# TOWN OF PLAINFIELD PLAN COMMISSION REPORT

**CASE NO.:** PP-23-036  
FDP-23-036

**REQUESTED ACTIONS:** Final Detailed Plan for Lot 1 of the Hall Business Park  
Primary Plat to create 3 non-residential lots

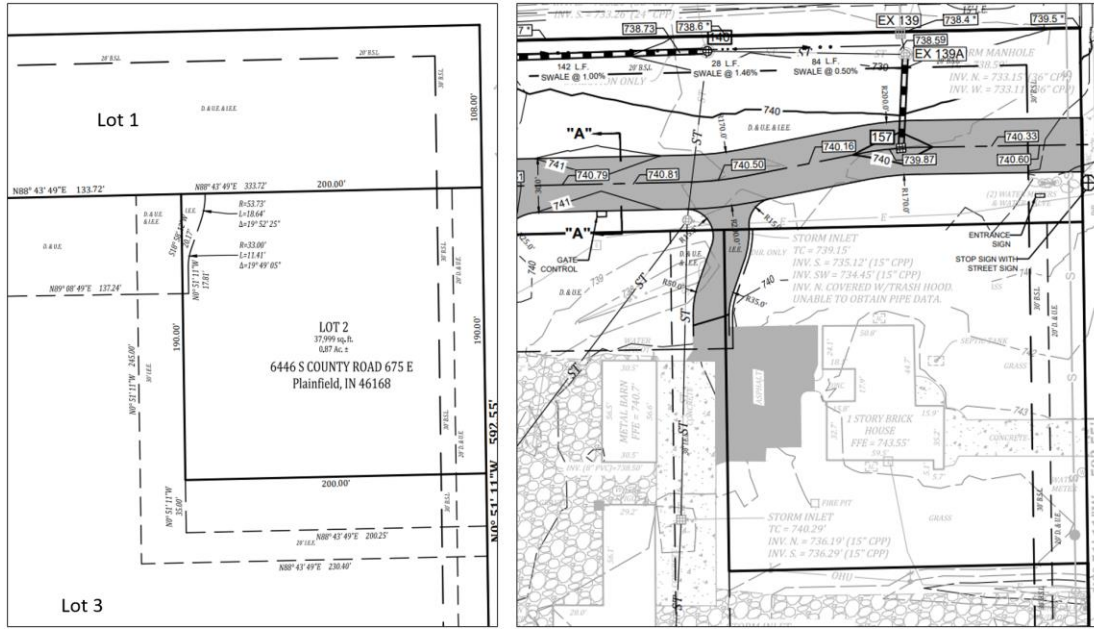
The FDP does not propose any new driveways and Staff has not requested a dedicated Traffic Impact Analysis given the generally low-volume use of storage facilities.

Lot 1 has a single point of access to public right-of-way, but the Petitioner has agreed to construct an Interior Access Drive over a platted 'I.E.E.' (Ingress-Egress Easement) that will encumber both Lot 2 and Lot 3. Placement of this drive is outside the expected security fence for Lot 1 and will provide an alternative access point should future construction impede the right-of-way access.
